Technical Guidance Committee Meeting

Minutes

Thursday, February 6, 2014

Figure 4-33. Design dimensions for use with the sand mound design checklist.

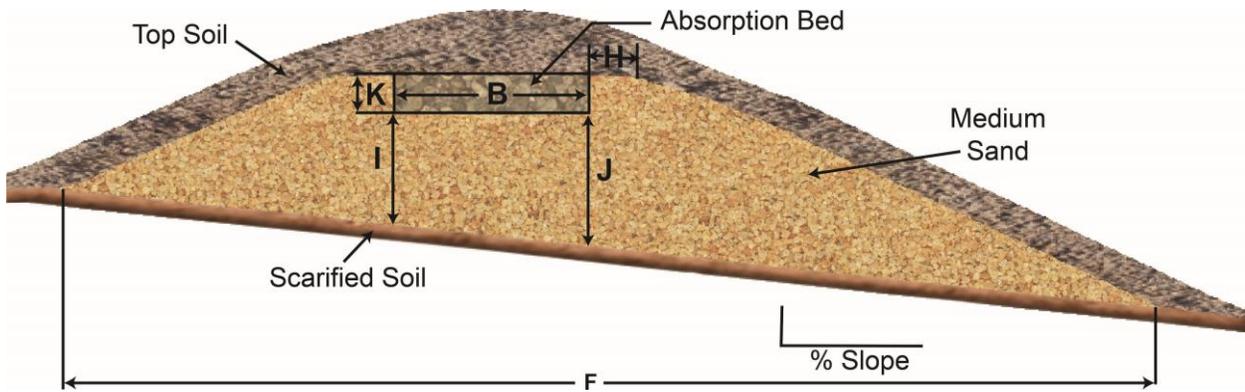
1. Move H in Figure 4-33 to a more visible location on the figure.
2. Adjust the design checklist and add back in items 7 and 8.
3. Look into suggested ripping/scarification widths and depths.
4. Move the 15 foot description in Figure 4-34 so it is not split by the arrow and make this dimension a minimum.

Figure 4-26. Cross section of recirculating gravel filter system.

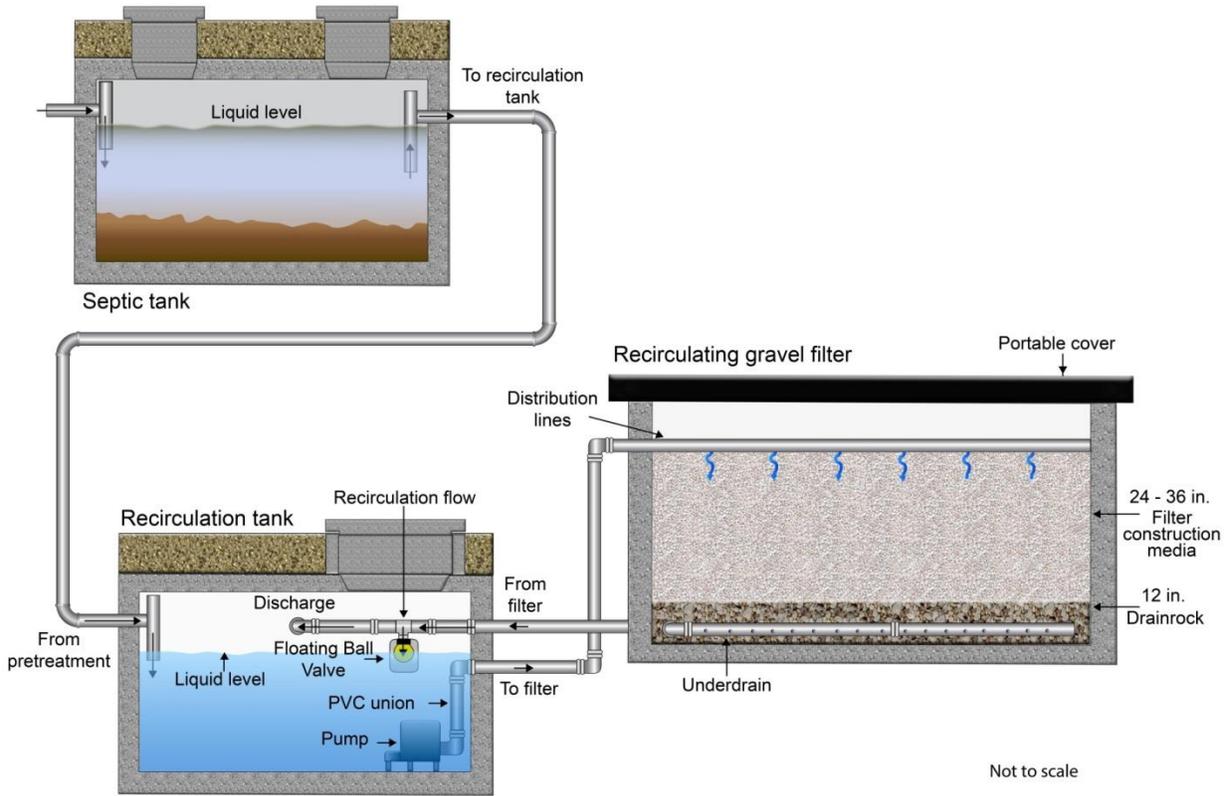
David Loper asked that Figure 4-26 be moved up in the section below section 4.24.2.7.b where the figure is first referenced.
